EXECUTIVE ORDER D-44
Relating to Exemptions under Section 27156
of the Vehicle Code

FAIRCHILD SEMICONDUCTOR
"KV ELECTRONIC IGNITION SYSTEM MODEL E 100"

Staff Report

Evaluation of the Fairchild Semiconductor
"K.V. Electronic Ignition System Model E 100" for Compliance
with the Requirements of Section 27156 of the California
Motor Vehicle Code

Figure 1 PEAK COIL SECONDARY OUTPUT VOLTAGE -VS- ENGINE RPM

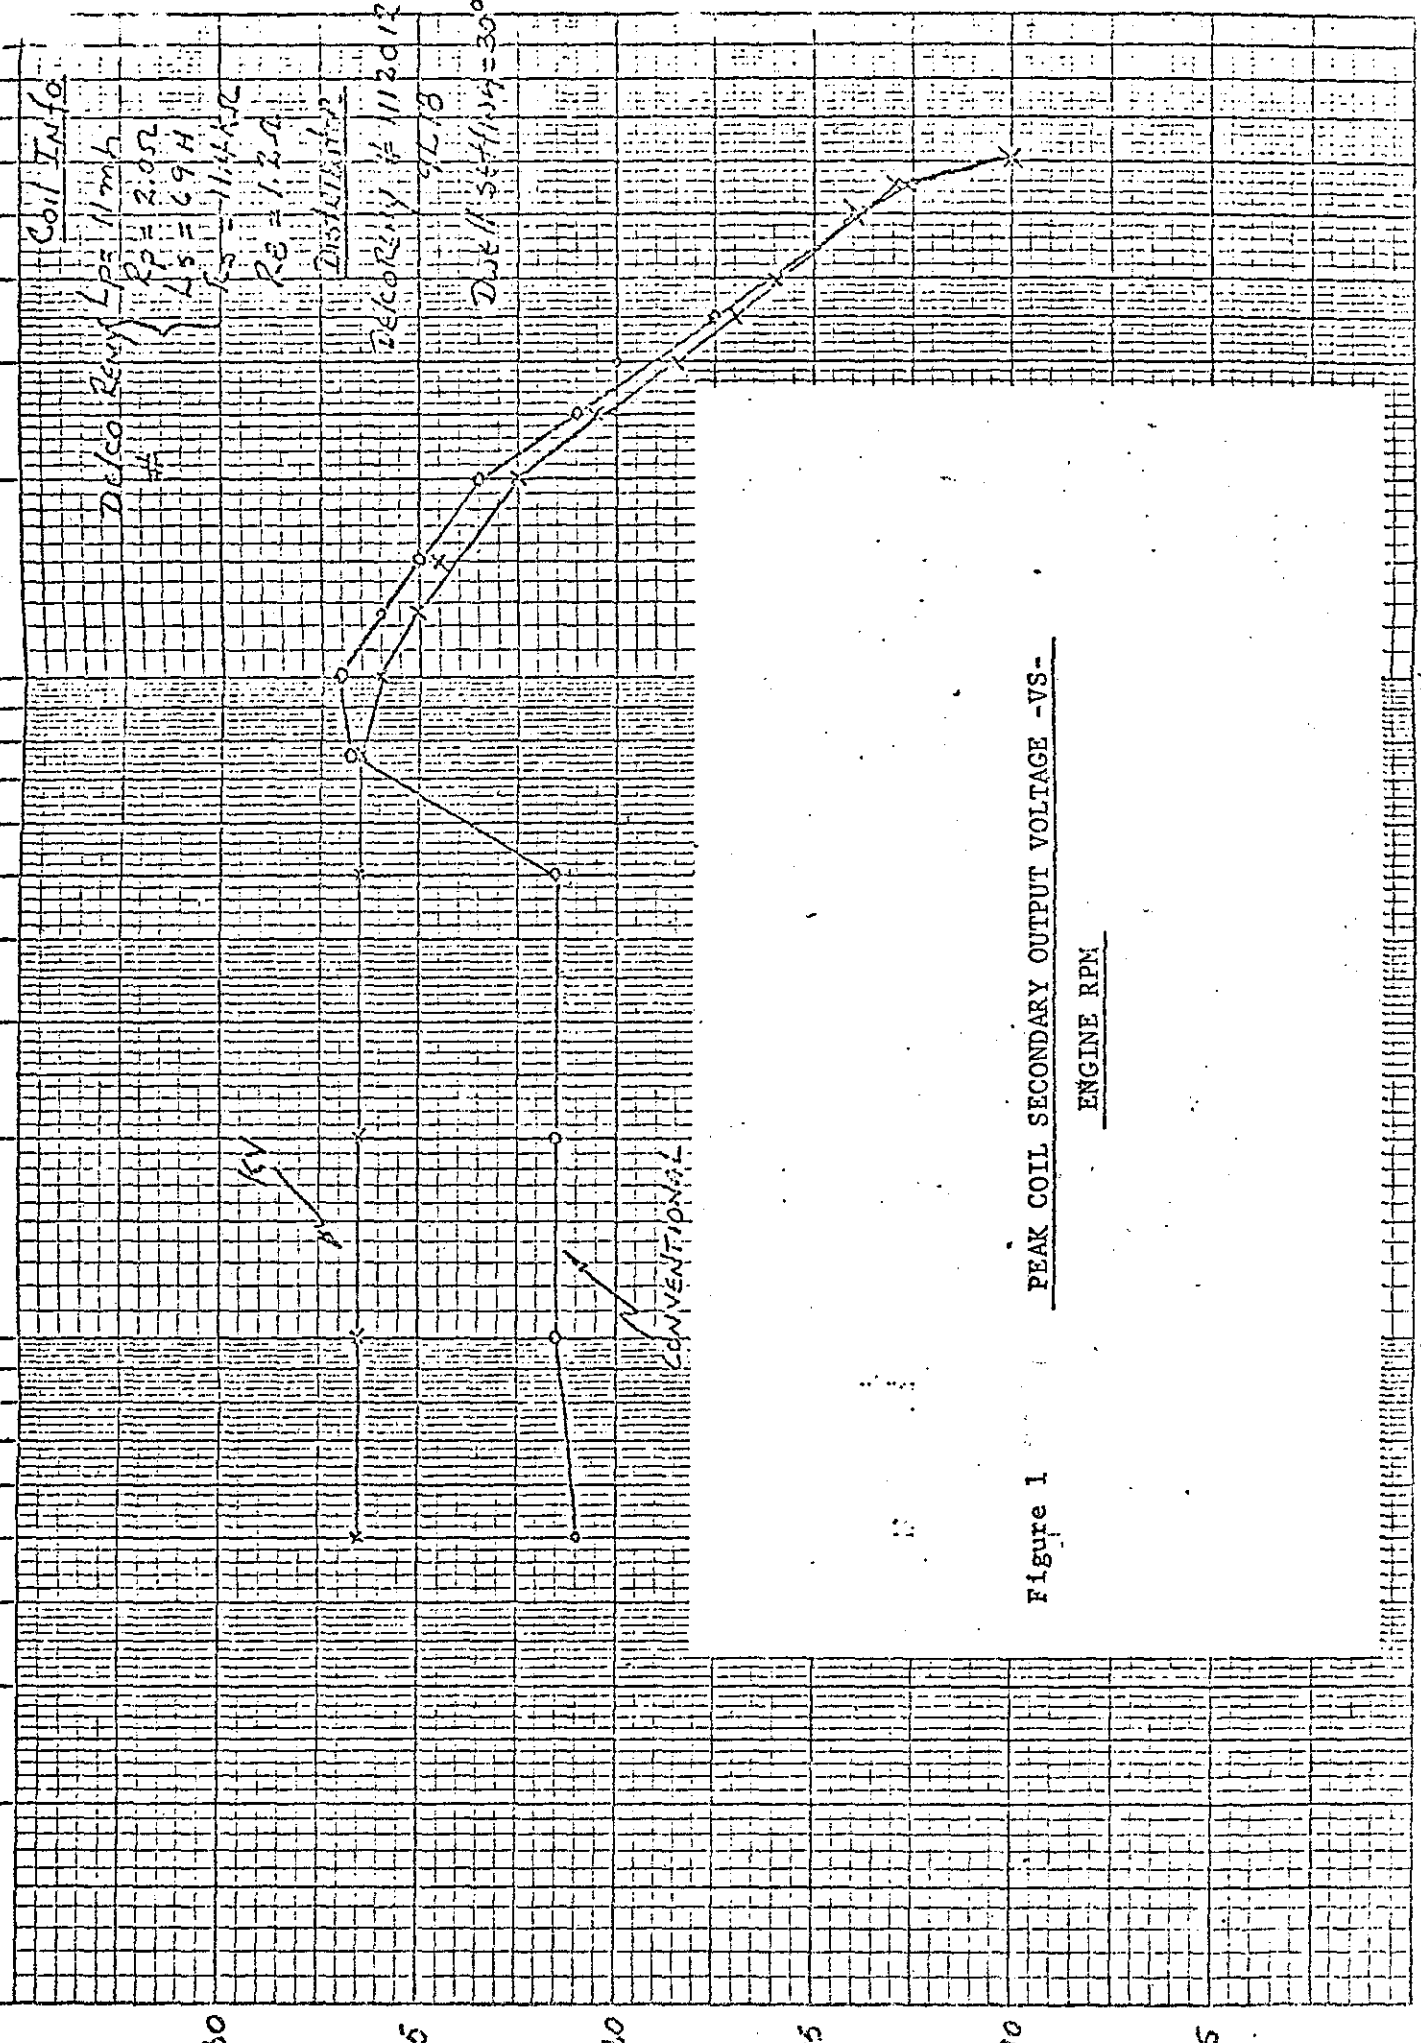
The applicant submitted data (Figure 1) comparing the electrical output of the "KV" device and the stock system. The available secondary voltages off idle is essentially the same. However, higher secondary voltages are encountered at idle and cranking speeds. No noticeable changes to the spark timing occurs with the device. The applicant presented data which show a 20 microsecond delay between the time the points open and the signal propagation from the transistor. This delay resulted in a retarded timing of 0.36 degrees at 3000 rpm. This retard is generally not measurable with common instruments.

One explanation for the differences between the applicant's and ARB secondary voltage data off idle may be due to the conditions of the points. Points that accumulated mileage generally exhibit a greater tendency to arc. The points used by the applicant were new while the points used by the ARB had accumulated 6000 miles. Therefore, the elimination of arching caused by the device would be expected to increase the secondary voltages observed in the ARB test results.
